Calculation Number: NAI-1149-018

Revision Number: 1

Title: Palisades Design Basis Main Steam Line Break AST Radiological Analysis

**Design Verification –** See Attachment 1 for Revision 0 comments  
See Attachment 7 for Revision 1 comments.

Figure 2 Fuel Damage Iodine Dose RADTRAD-NAI Model

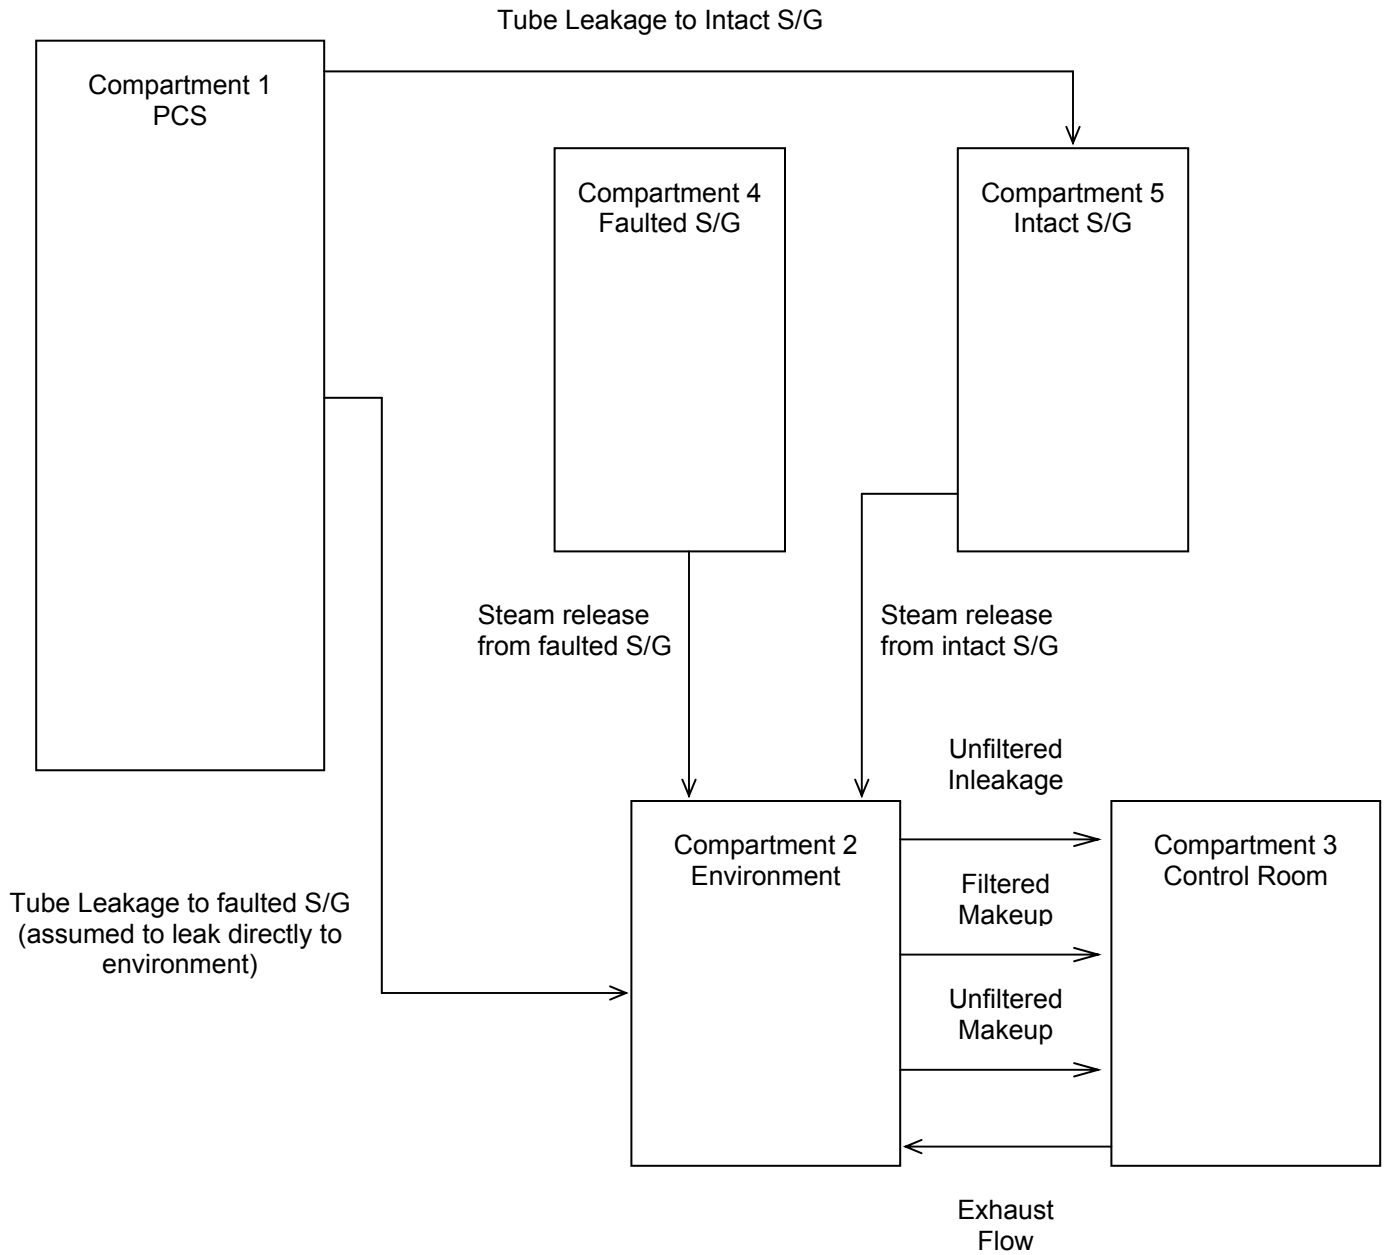
**Comment 7**

Attachment 5 – The plant power and PCS volume in the psf file for the fuel damage case are incorrect. The plant power should be 2703 as per Sections 7.2.10 and 7.1.9 of the calculation and the PCS volume should be 432,977 as per Sections 7.2.1 and 7.1.1 of the calculation. These correction should be made and the case should be re-run and the results should be replaced in the attachment and results table.

*Response: Corrections made.*
